## TEXAS COMMISSION ON ENVIRONMENTAL QUALITY

Re: Edwards Aquifer, Comal County  
NAME OF PROJECT: Metamorphic Design; located at 18636 Forty-Six Parkway, Bulverde, Texas  
TYPE OF PLAN: Request for the Approval of a Contributing Zone Plan (CZP); 30 Texas Administrative Code (TAC) Chapter 213 Subchapter B Edwards Aquifer  
Edwards Aquifer Protection Program San Antonio File No. 232.01; Investigation No. 826029  
Regulated Entity No. RN105187652; Additional ID 13-07021306

**RE:** Metamorphic Design CZP (EAPP No. 232.01)  
Response to Additional Comments

Re: Metamorphic Design Contributing Zone Plan (CZP)  
Edwards Aquifer Protection Plan (EAPP) No. 232.01  
Response to Notice of Deficiency (NOD)

**EXHIBIT 3**

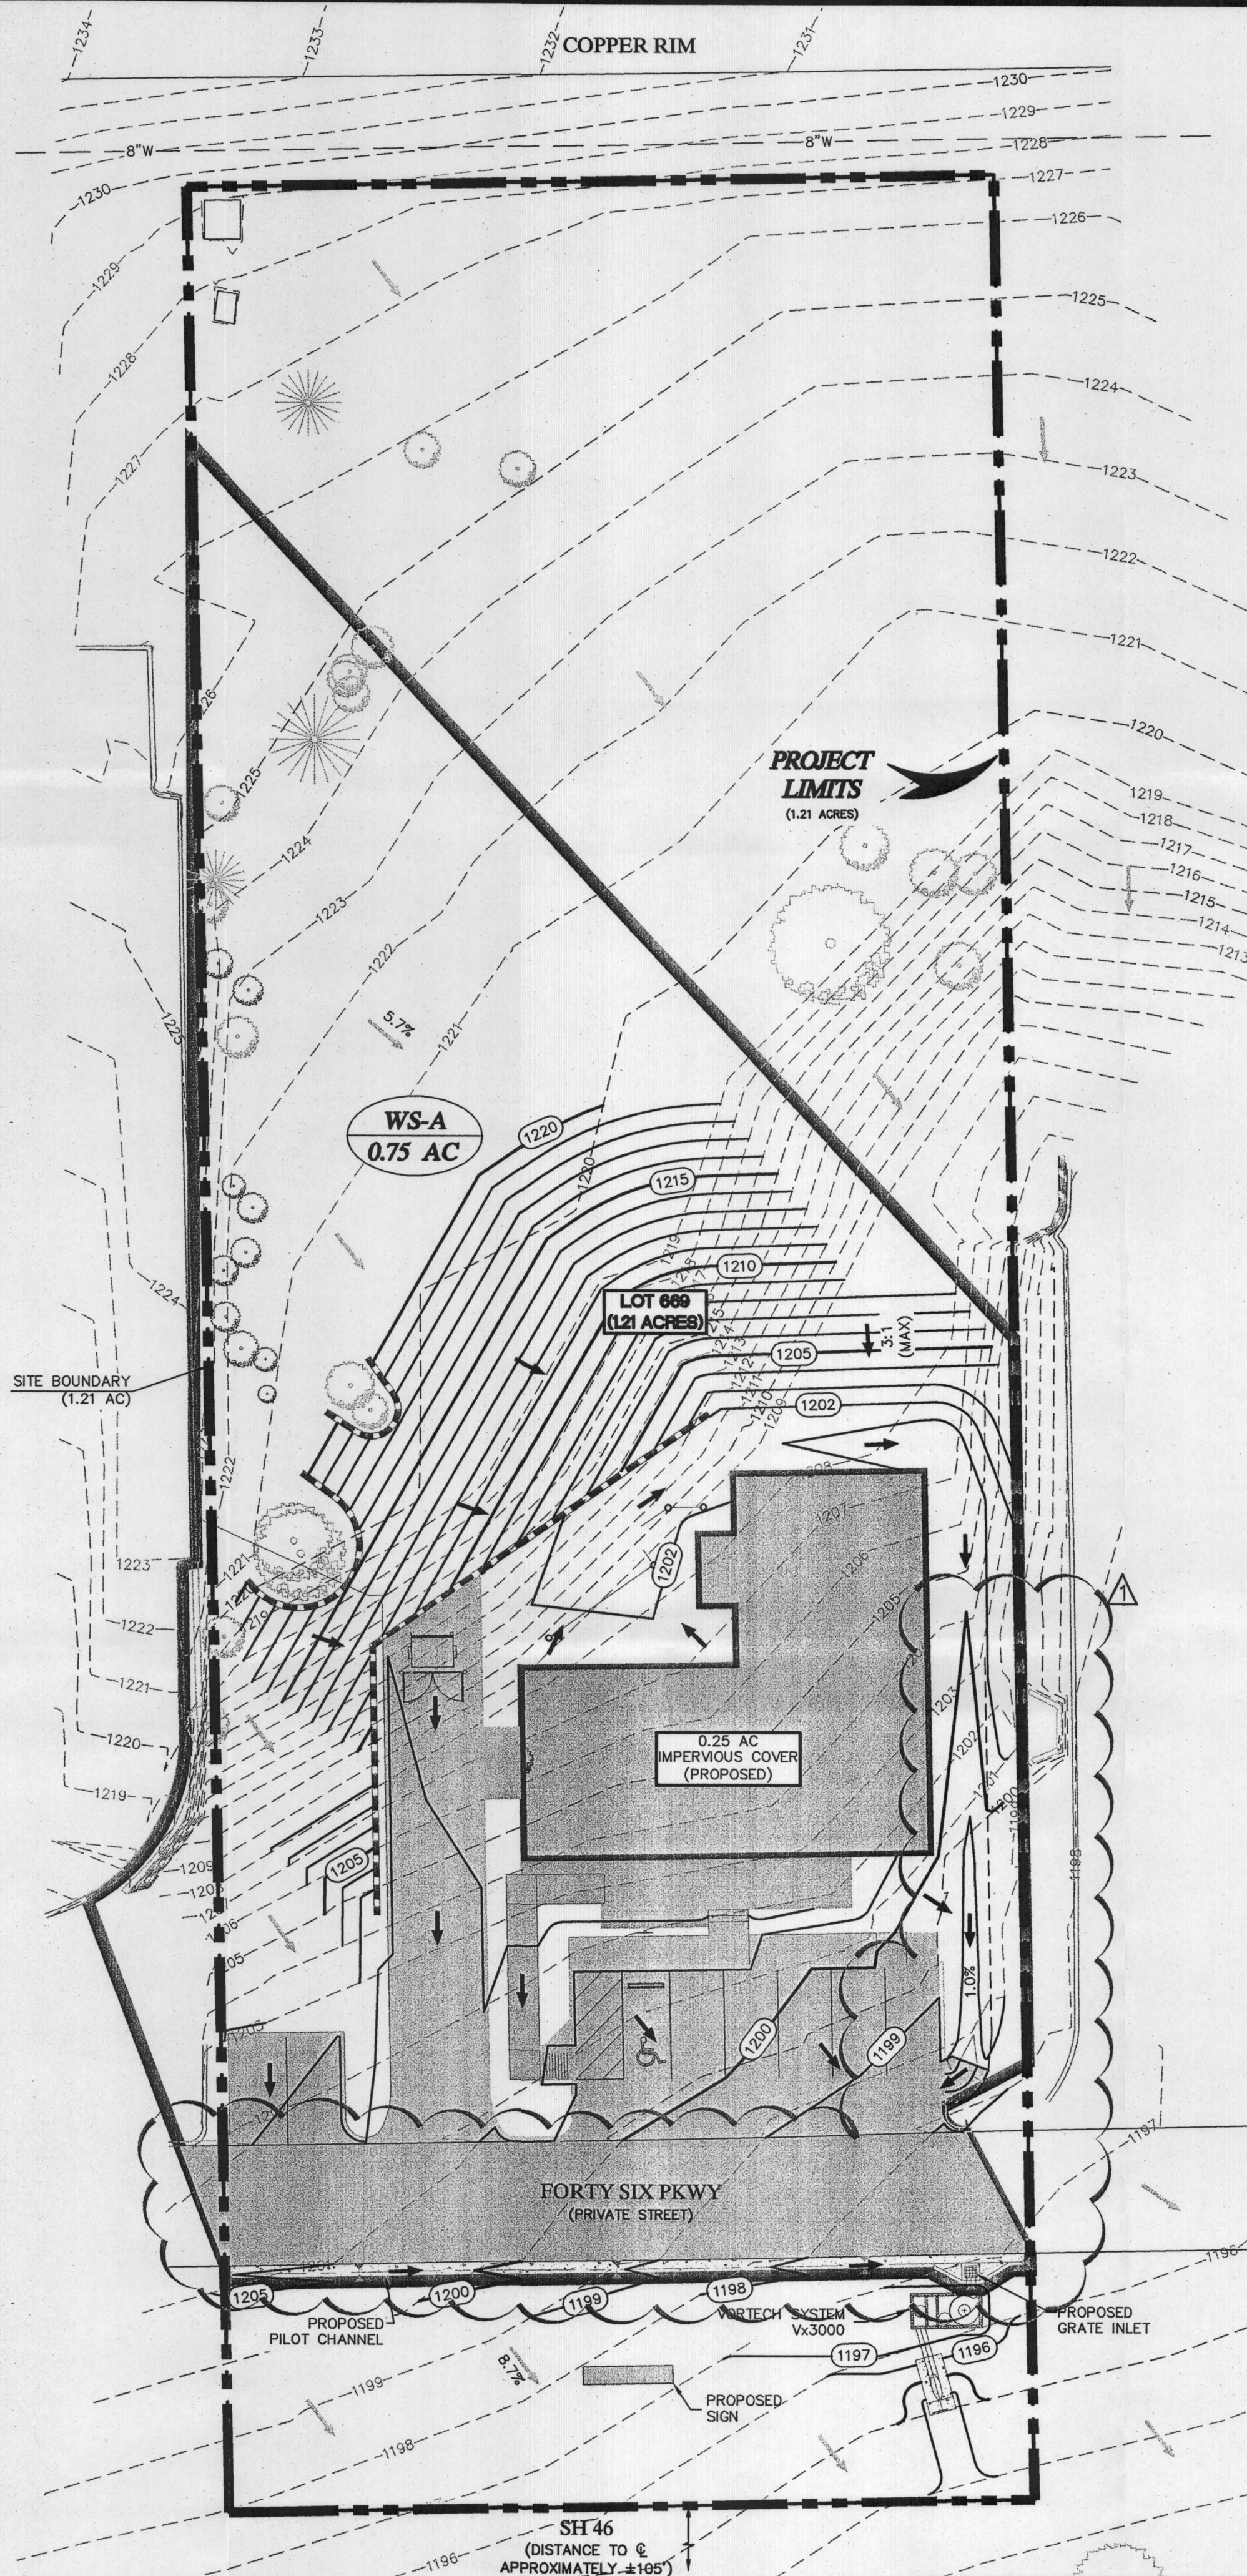
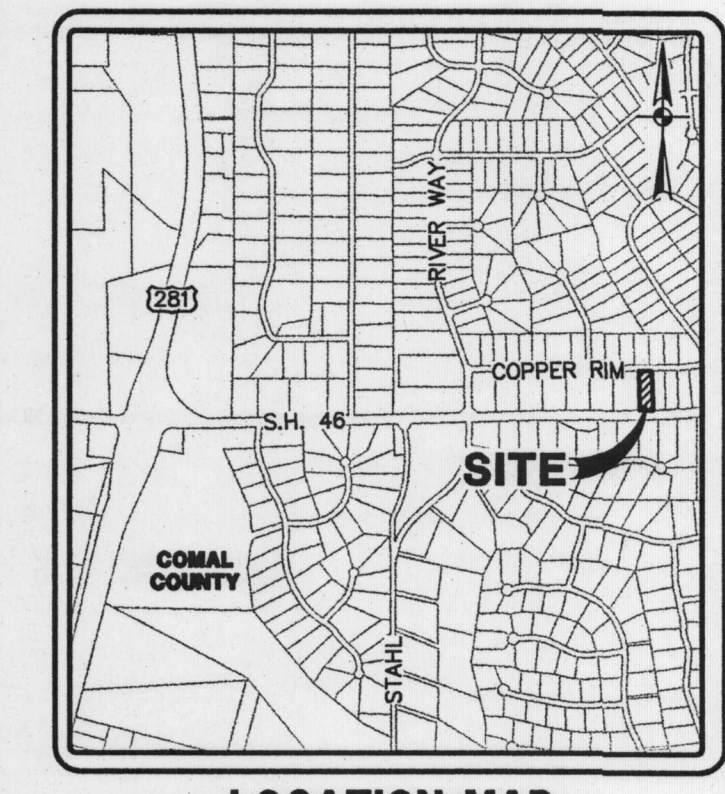
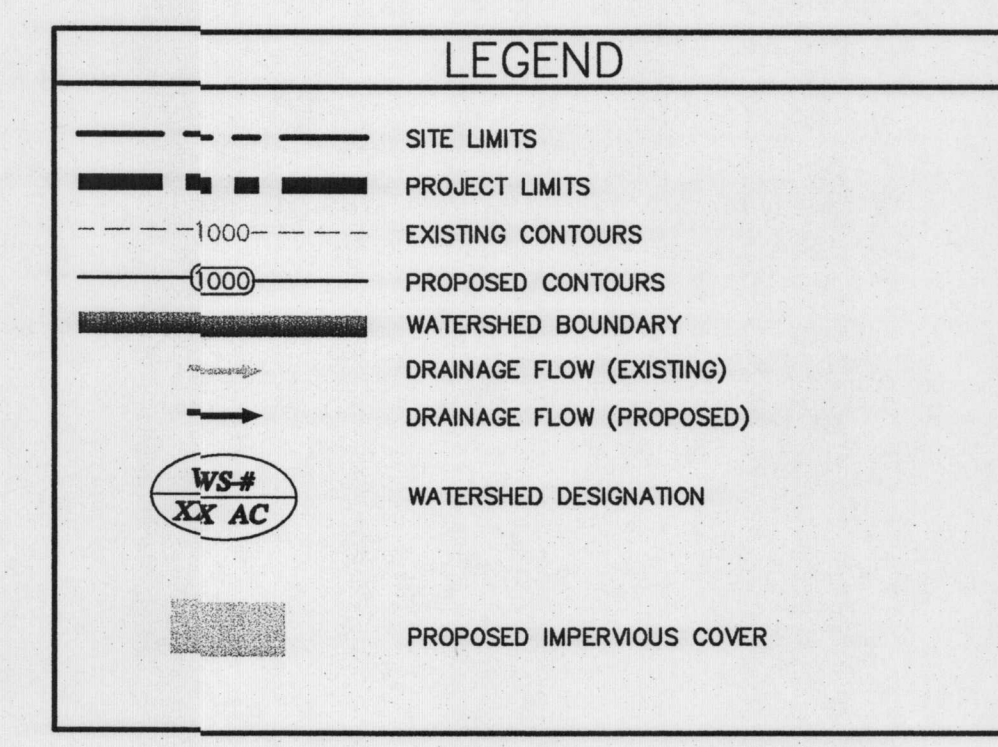
- b. Specifically label on the Site Plans the areas which will be disturbed and clarify Item 35 accordingly.
  - c. On Exhibit 3, provide revisions to the data tables and plan view for the changes in treatment calculation assumptions and results and the proposed BMT.

- a. *This statement appears to be direction to the user and not an actual construction note; therefore, it is not included.*
- b. *The limits of disturbance are approximately 0.641 acres, from the southern property line to the limits of grading shown on the plans. This boundary has been added to Exhibit 1.*
- c. *Please see the response to "2.a" of the TCEQ-10257 comments below.*
- d. *The outfall from the Vortechs unit is shown on Exhibit 1 and 3. Flow is discharged via pipe to a grassed area at the southern property line. No revision is necessary. Flow will ultimately flow to a ditch running parallel to the highway diverting upgradient flow to an existing crossing underneath SH46.*

- a. *Treatment is being provided for Forty Six Parkway. In addition, grading has been revised to capture runoff previously uncaptured. Please see the revised exhibits and TSS calculations attached. No change to the Vortech model is necessary and no additional permanent BMPs required.*
